TOWN OF WINCHENDON

AGENDA & NOTICE OF MEETING

BOARD/COMMITTEE: Planning Board – Public Hearings & Meeting

DATE: November 19, 2019

PARKING SPOT LAYOUT

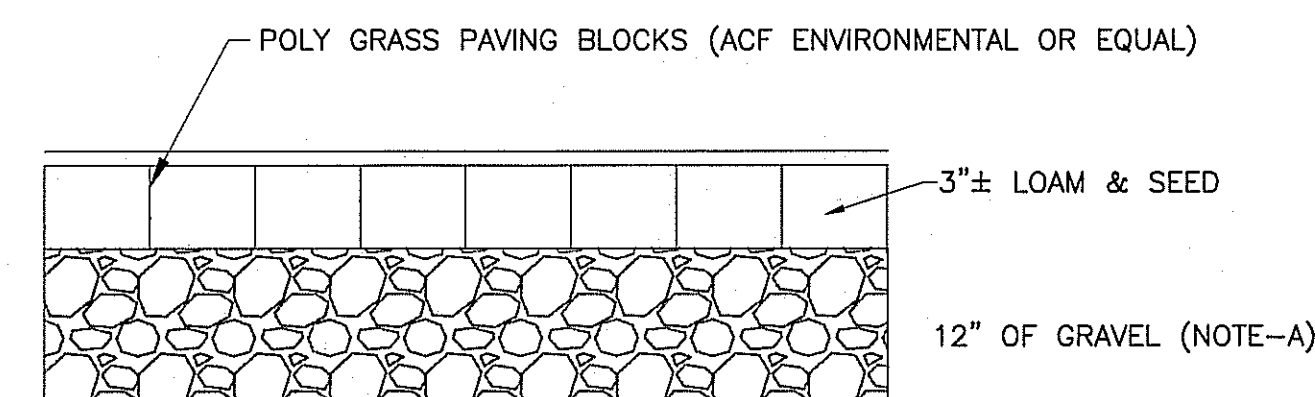
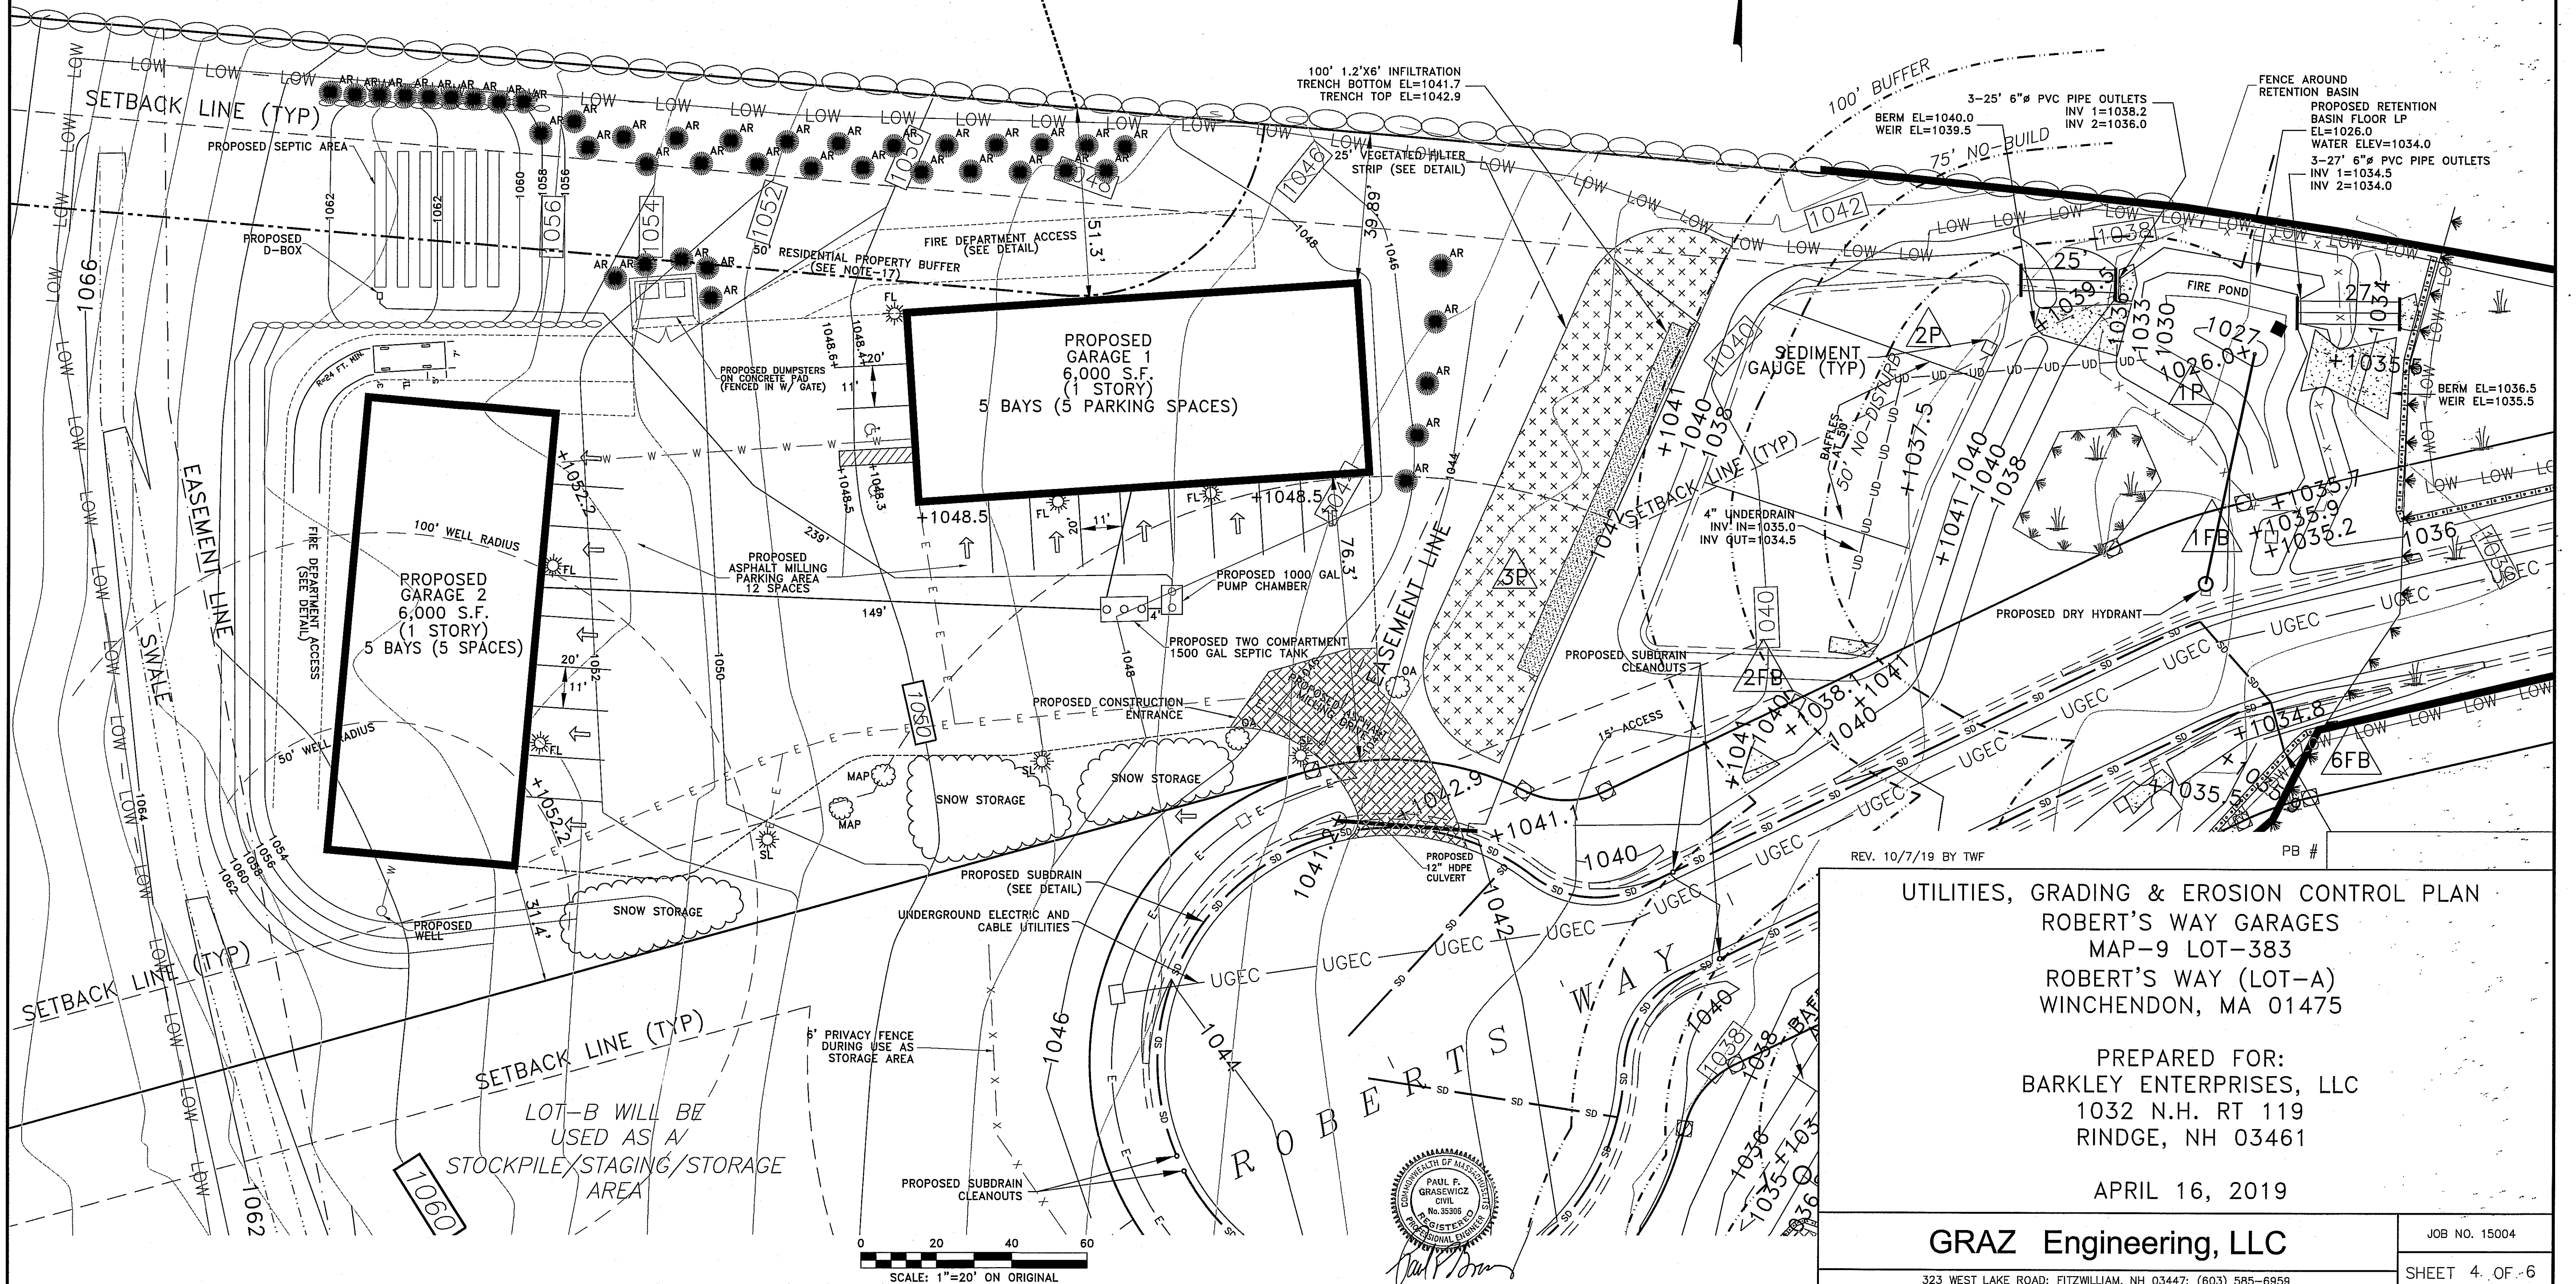
12. The parking lot detail (Sheet 6) does not agree with the parking lot layout provided on Sheet 3. The Applicant should confirm the intent of the parking layout.

UTILITIES, GRADING, EROSION CONTROL, AND
 LANDSCAPING PLAN
 ROBERT'S WAY STORAGE UNITS
 MAP-9 LOT-383
 ROBERT'S WAY (LOT-C)
 WINCHENDON, MA 01475

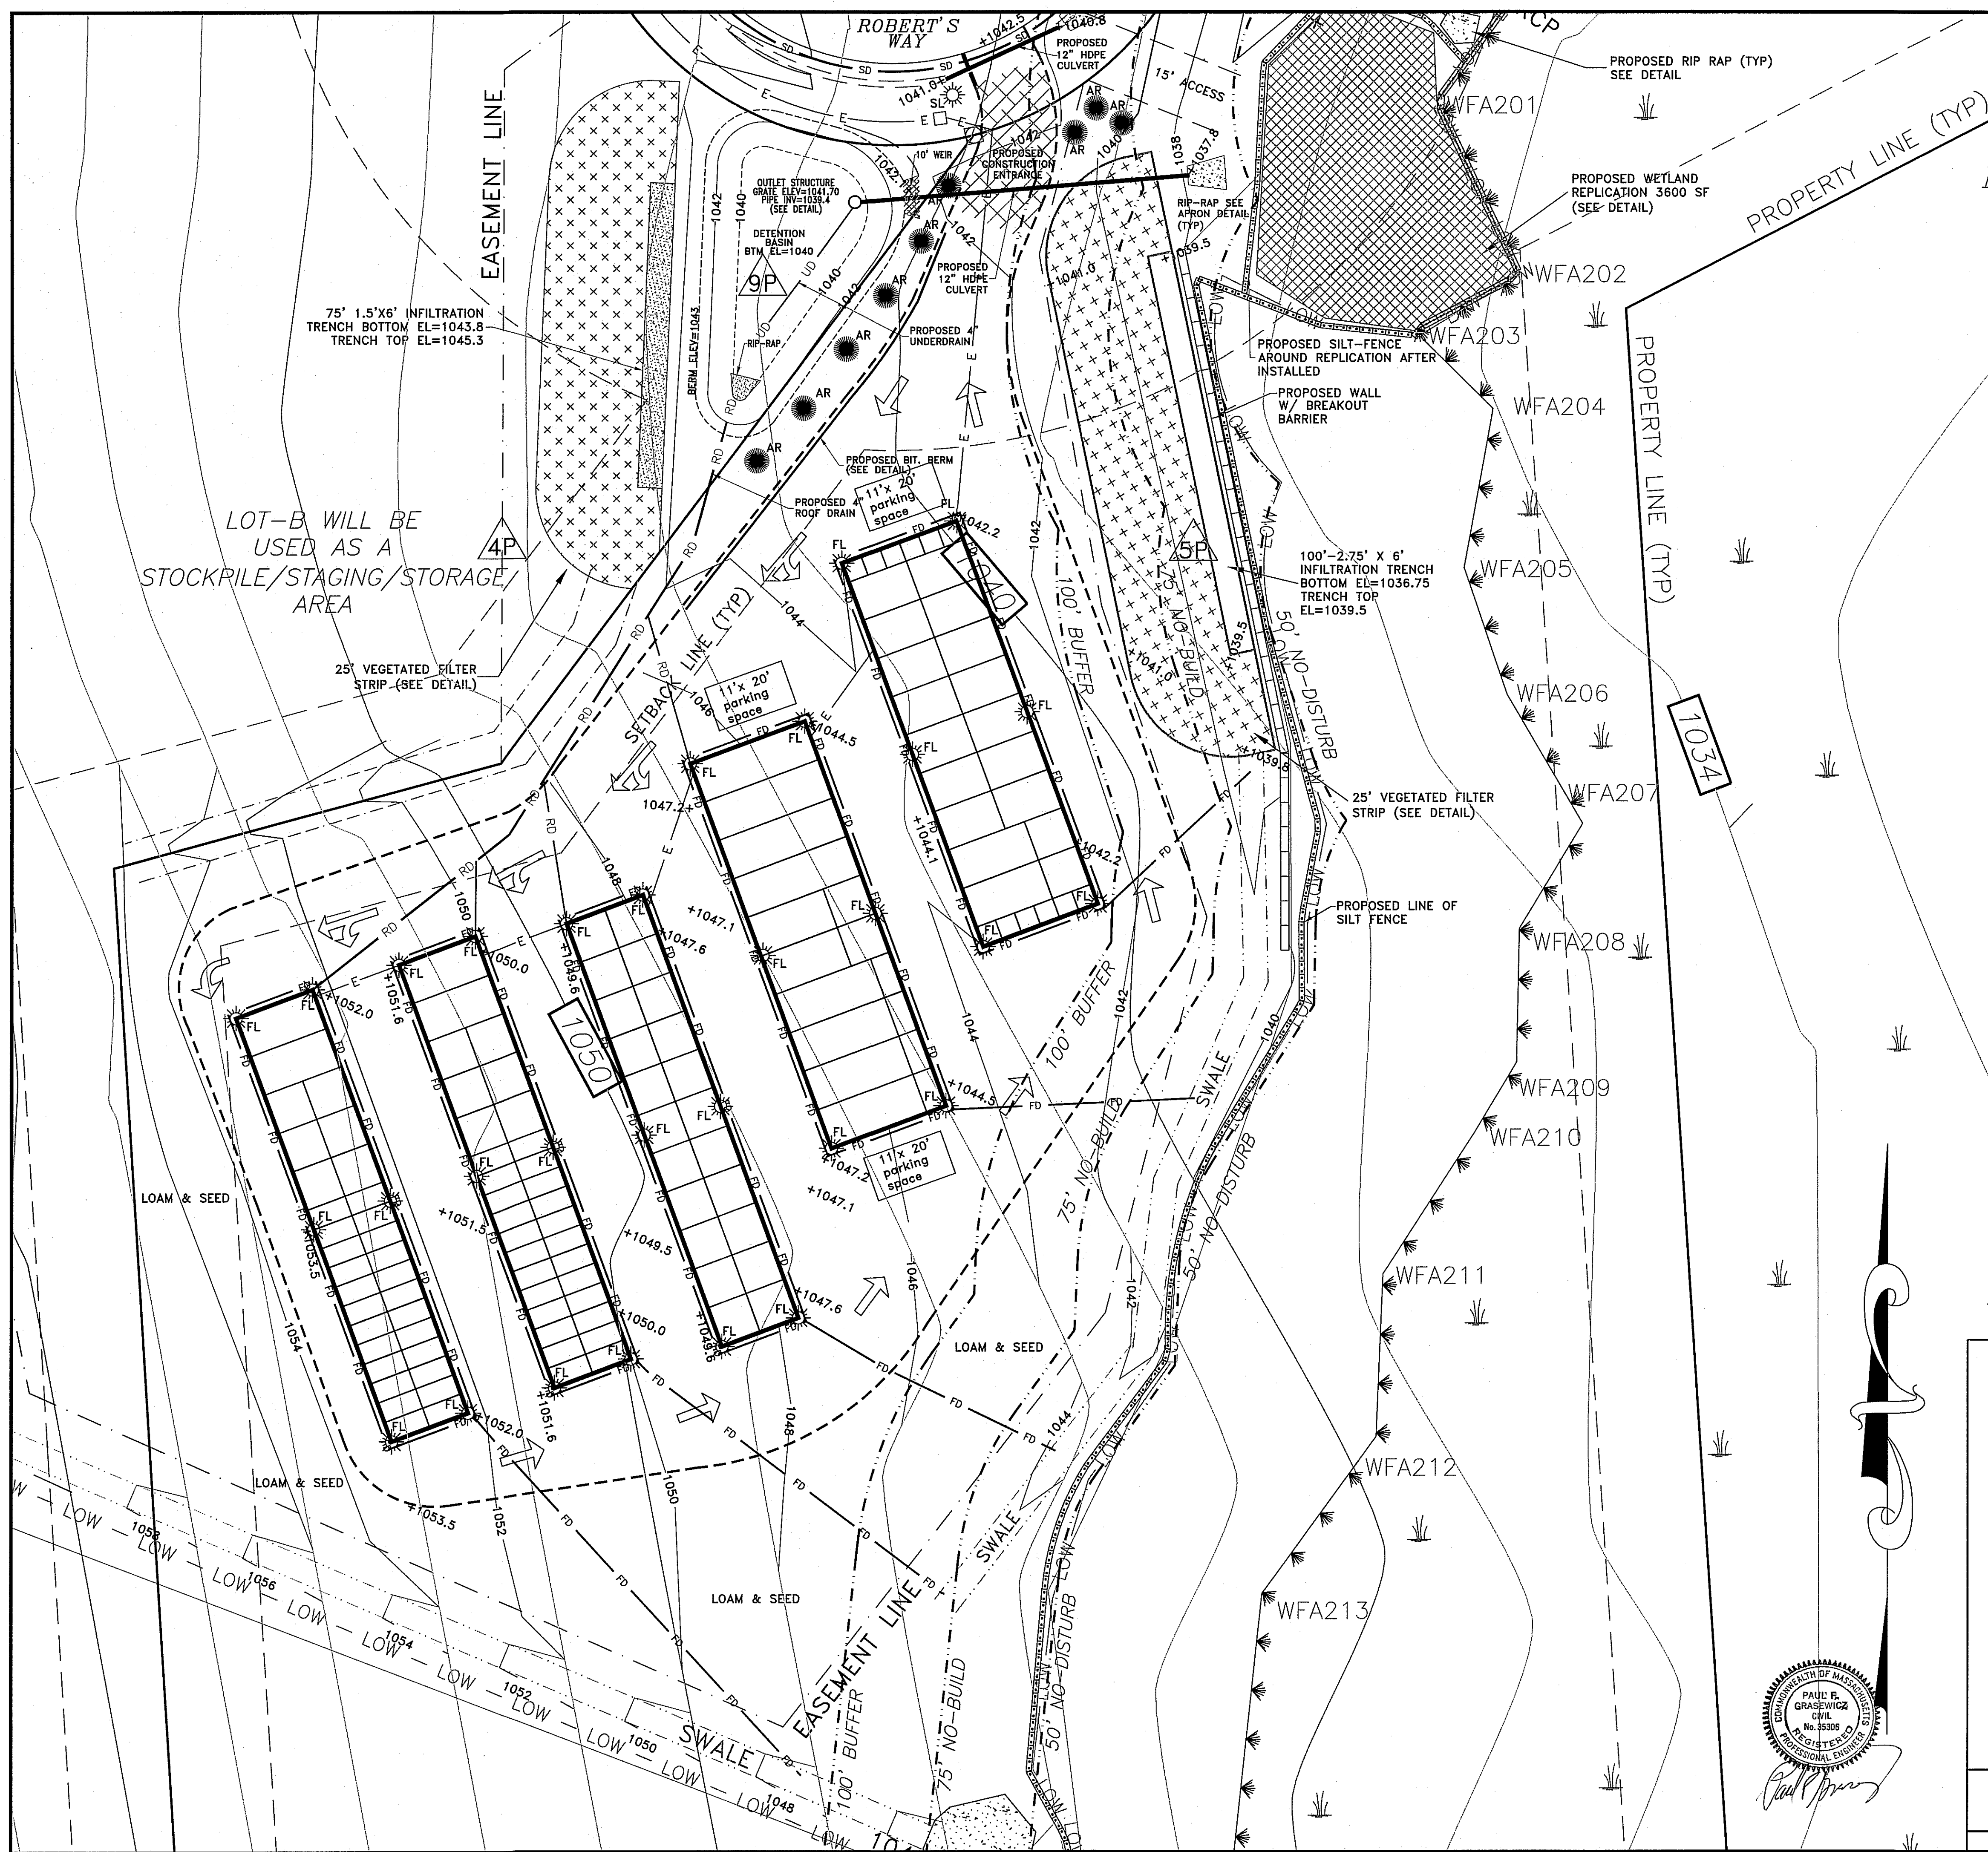
29. Sheet 4 of the Lot C NOI project drawings include a cross-hatched area adjacent to wetland flags WFA201, WFA202, and WFA203 that is called out as "Proposed Wetland Replication 3600 SF (see detail)." Based on Tighe & Bond's June 2019 telephone conversation with Mr. Koonce, we understand this area was prepared as mitigation for the construction of the Robert's Way roadway under MassDEP File #345-0641.

We note the 50- and 75-foot local setbacks and 100-foot Buffer Zone are drawn from the previously delineated wetland boundary (WFA201 through WFA213 within the plan view of sheet 4), and not from the boundary of the "proposed" wetland replication area. The success of this BVW replication area is critical to compliance with the previously issued Order for MassDEP File #345-0641.

30. In consideration of Comment 20, alterations, including grading/earthwork and the construction of stormwater management features, are proposed within the 50-foot setback of undisturbed natural vegetation as noted above and shown on sheet 4 of the project drawings. The Lot C NOI materials provided for this peer review did not include a request for waiver from the requirements of §29.9 of the Winchendon Wetlands Protection Bylaw.

GRAZ Response 10/18/19: Additional notes have been added to sheet-4.

T&B Response 10/24/19: We recommend the Commission confirm that the MassDOT seed mix, as referenced on Sheet 4, does not include any invasive or non-native species.
